2 RESPONSE TO COMMENTS ON THE DRAFT EIS/EIR

Subject: Draft Environmental Impact Statement/Environmental Impact Report for the Squaw Valley Alpine Meadows Base-to-Base Gondola Project, Tahoe National Forest. (EIS No. 20180070)

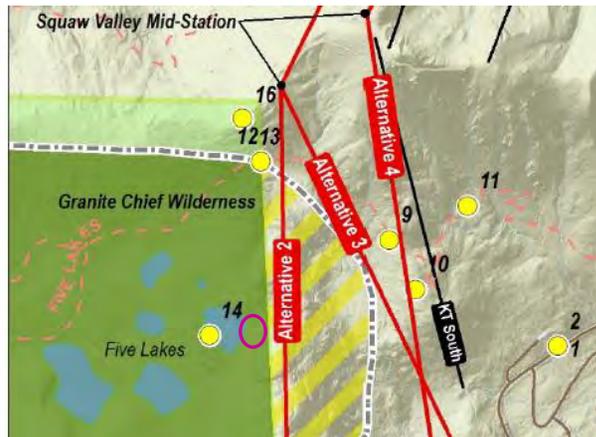
0144-9

Additional viewpoints within Five Lakes Basin:
